Access Compliance Report

Public Rights-of-Way

(Curb Ramps)

Intersection ID: 49930	Main Street: PAXTON_RUN_RD	Cross Street: CHAMBERLIN_RD	Location: SE
ADA ID: 22D6A9B166A9	Ramp Type: Perp	Initial Pass/Fail: Fail	Overall Compliance: No
Severity Score: 25			
Codes/Mitigation Info/Possible Solution		Field Measurements/Component Compliance

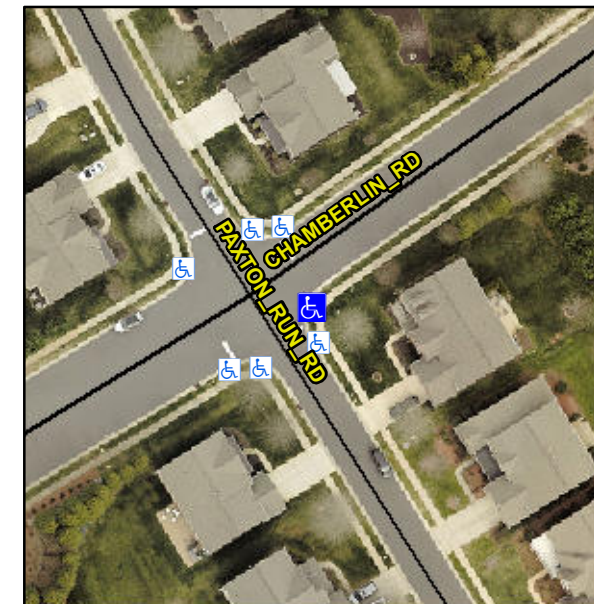
Not Found, R304.2.2, R304.5.3

Compliance	Description	Data	Compliance	Description	Data
N/A	Ramp Length (in)	47.0	No	Ramp Slope (%)	8.7
Yes	Ramp Width (in)	48.0	No	Ramp XSlope (%)	5.8
N/A	Flare Type LT	N/A	N/A	Flare Type RT	N/A
N/A	Flare Slope LT (%)	N/A	N/A	Flare Slope RT (%)	N/A
N/A	Flare Traversable LT?	N/A	N/A	Flare Traversable RT?	N/A
N/A	Landing Length (in)	N/A	N/A	DWS Provided?	N/A
N/A	Landing Width (in)	N/A	N/A	DWS Contrast?	N/A
N/A	Landing Slope (%)	N/A	N/A	DWS Length (in)	N/A
N/A	Landing X Slope (%)	N/A	N/A	DWS Full Width?	N/A
N/A	Landing Curb? (Y/N)	N/A	N/A	DWS Offset (in)	N/A
N/A	Shared Landing?	N/A			
N/A	Gutter Ponding?	N/A	N/A	Gutter Slope (%)	N/A
N/A	Gutter Lip Ht (in)	N/A	N/A	Gutter X Slope (%)	N/A
N/A	Painted X Walk1?	No	N/A	Painted X Walk2?	N/A
	X Walk 1 Direction	To NW		X Walk 2 Direction	N/A
N/A	X Walk 1 Width (in)	N/A	N/A	X Walk 2 Width (in)	N/A
	X Walk 1 Slope (%)	5.9		X Walk 2 Slope (%)	N/A
	X Walk 1 X Slope (%)	1.8		X Walk 2 X Slope (%)	N/A

Remove & Replace Entire Ramp.
